**RECORD OF DECISION AMENDMENT  
OPERABLE UNIT 1  
SOIL AND OVERBURDEN GROUNDWATER**

**SPECTRON, INC. SUPERFUND SITE  
ELKTON, CECIL COUNTY, MARYLAND**

**UNITED STATES ENVIRONMENTAL  
PROTECTION AGENCY**

**REGION 3  
PHILADELPHIA, PENNSYLVANIA  
March 2012**

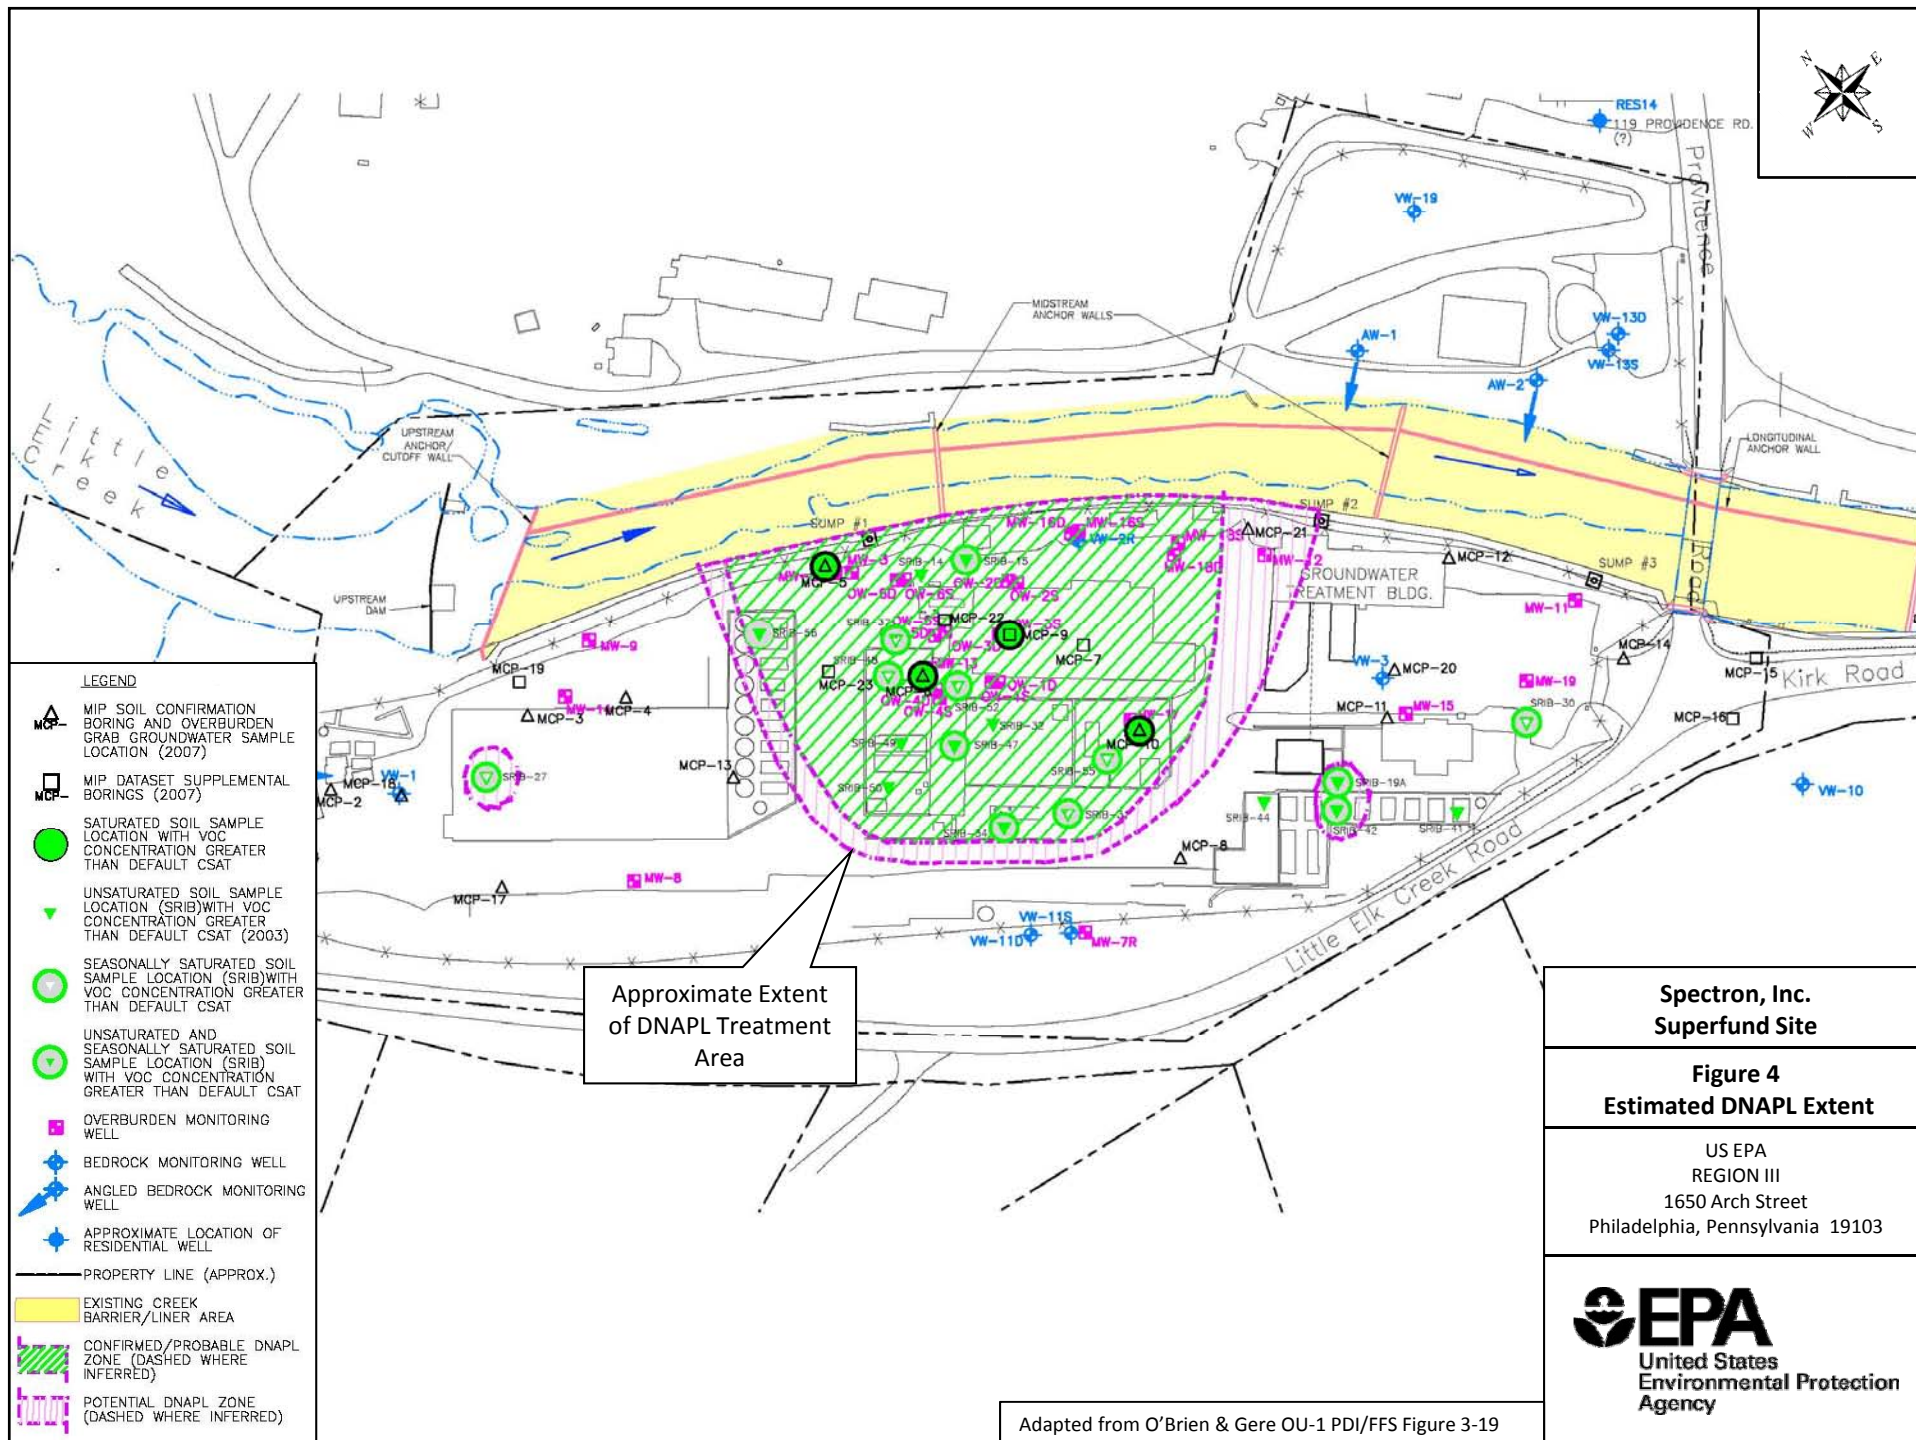
Based on these factors, EPA proposes to modify the remedy to include the installation of an asphalt (or equivalent) cap instead of the installation of the RCRA modified cap prescribed by the 2004 OU-1 ROD. Consistent with the currently selected remedy, all onsite structures will be demolished, staged debris will be placed onsite, and the Site will be graded prior to installation of the cap. The condition of existing asphalt and/or concrete areas at the Site will be evaluated during Remedial Design to determine what portions, if any, can be incorporated into the final cover. The asphalt (or equivalent) cap will be installed over the same area as required by the 2004 OU-1 ROD, encompassing the entire Plant Area and Waste Management Area (WMA) as shown on Figure 3.

Based on this evaluation, EPA proposes to modify the remedy to include the installation of an asphalt (or equivalent) cap in lieu of the RCRA modified cap prescribed by the 2004 OU-1 ROD. In accordance with the 2004 OU-1 ROD, prior to installation of the asphalt (or equivalent) cap, all onsite structures will be demolished, staged debris will be placed onsite, and the Site will be graded. The condition of existing asphalt areas at the Site will be evaluated to determine what portions, if any, can be incorporated into the final cover. The asphalt (or equivalent) cap will be installed over the same area as required by the 2004 OU-1 ROD, encompassing the entire Plant Area (Figure 3).

An asphalt (or equivalent) cap will be installed at the Site in lieu of the RCRA modified cap prescribed by the 2004 OU-1 ROD. Consistent with the currently selected remedy, all onsite structures will be demolished, staged debris will be placed onsite, and the Site will be graded prior to installation of the cap. The asphalt (or equivalent) cap will be installed over the same area as required by the 2004 OU-1 ROD, encompassing the entire Plant Area (Figure 3).
